PCR-2010-280

PLANNING CLEARANCE

Building Address 560 Normandy Dr
 Parcel No. 2943-071-08-003
 Subdivision Rothbaept
 Filing _____ Block _____ Lot _____

DESCRIPTION OF WORK & INTENDED USE:
 New Single Family Home (*check type below)
 Interior Remodel Addition
 Other (please specify): carport in back
connected to garage
8' x 32'

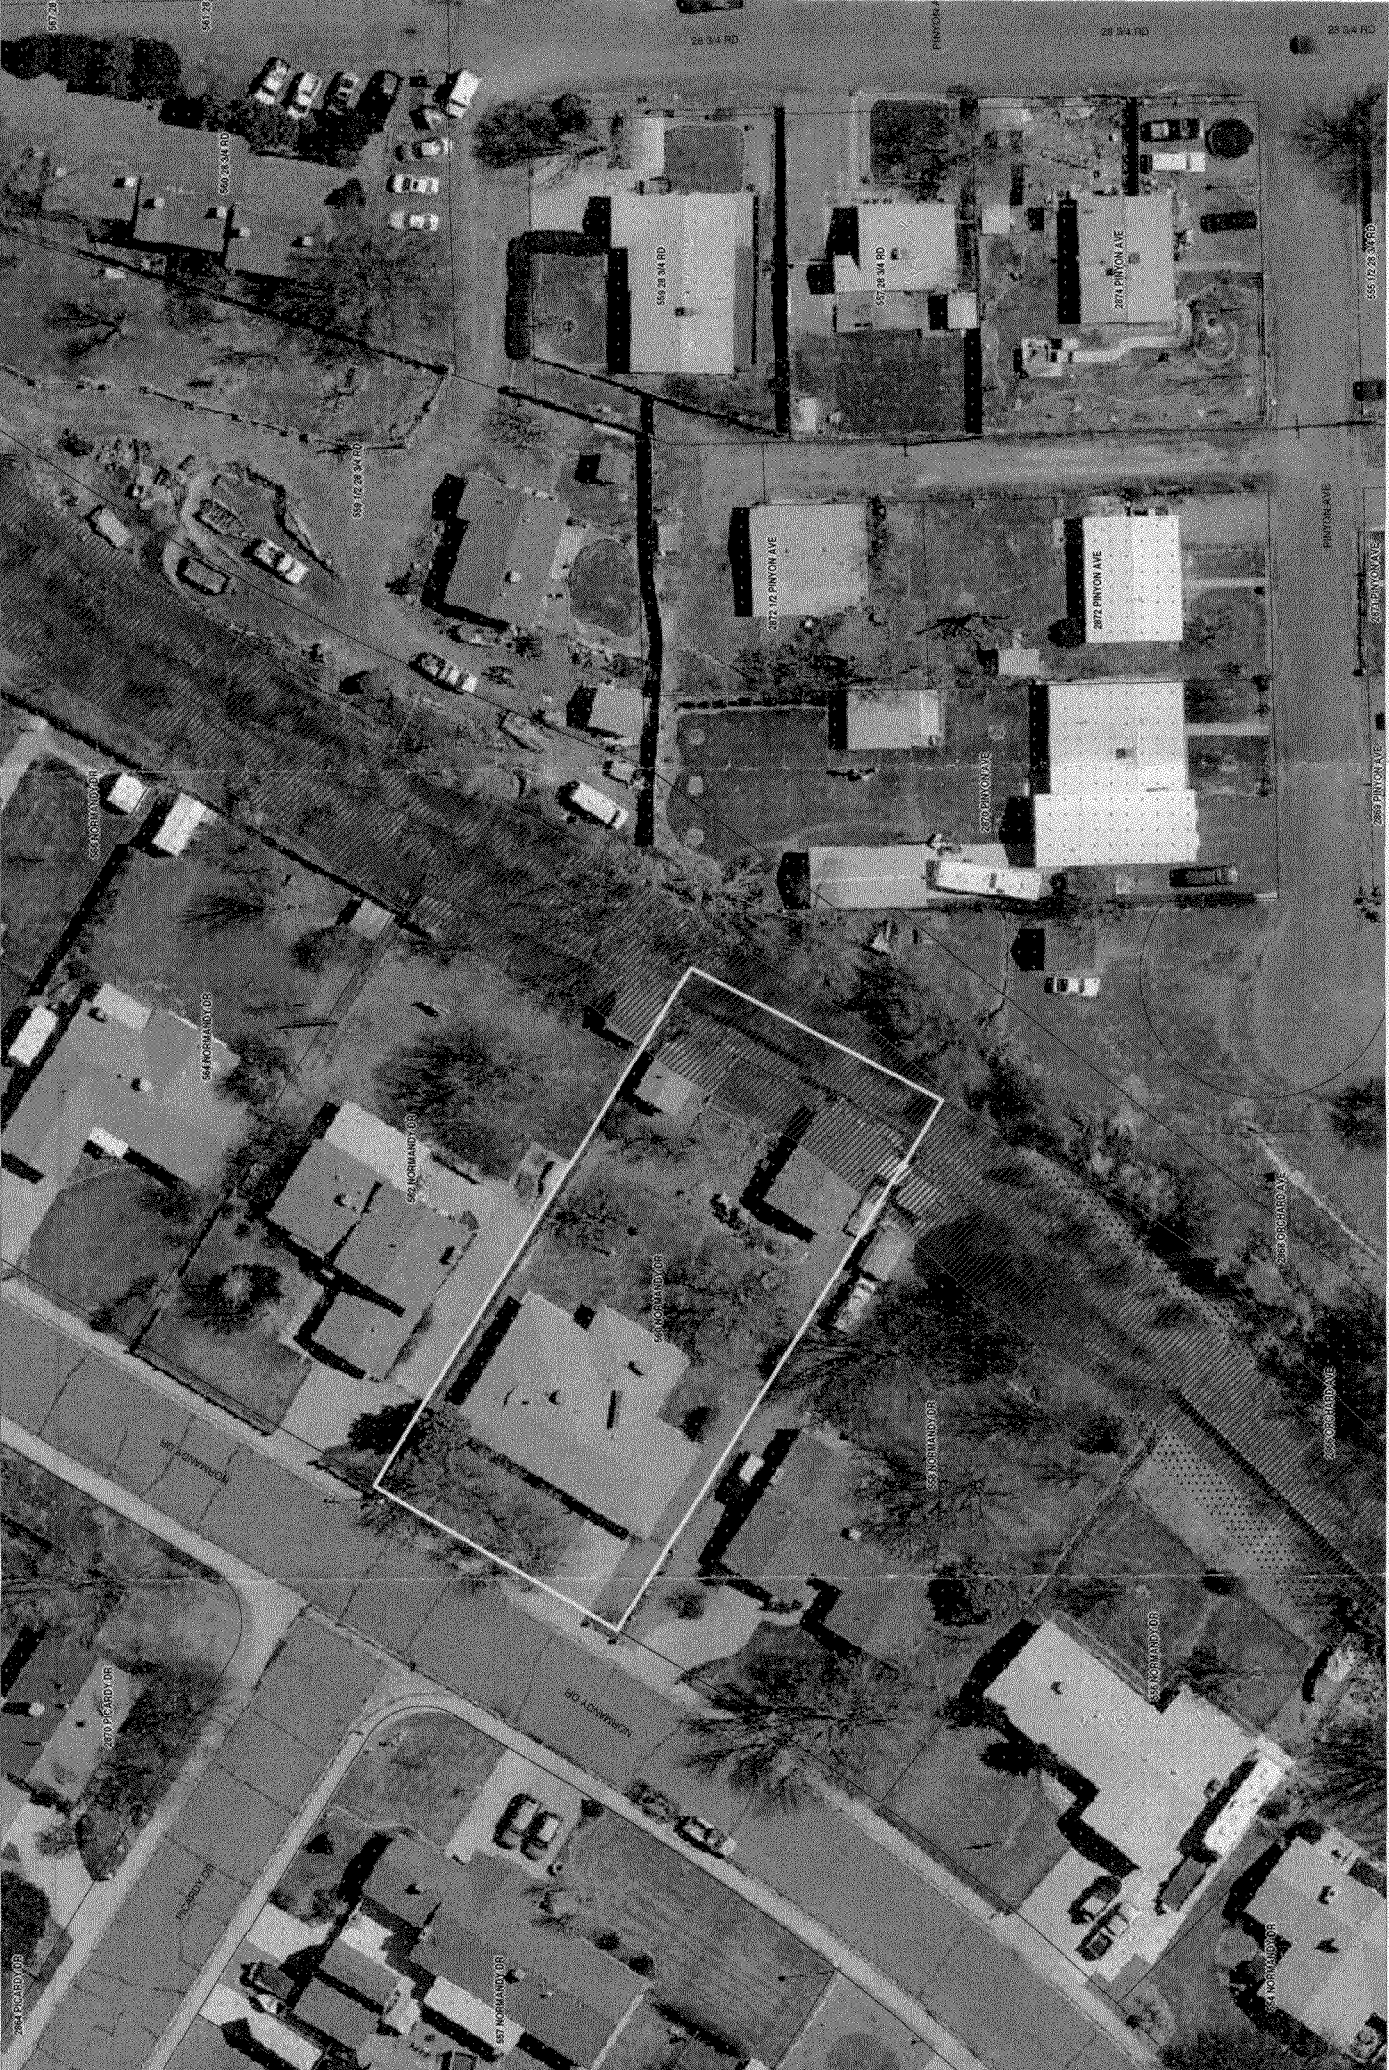
ACCEPTED *Pat O'Connell 10/21/10*
ANY CHANGE OF SETBACKS MUST BE APPROVED BY THE CITY PLANNING DIVISION. IT IS THE APPLICANT'S RESPONSIBILITY TO PROPERLY LOCATE AND IDENTIFY EASEMENTS AND PROPERTY LINES.

PROPOSED 8' x 32' CARPORT ADDITION
EXISTING SETBACK 11'
PROPOSED SETBACK 3'
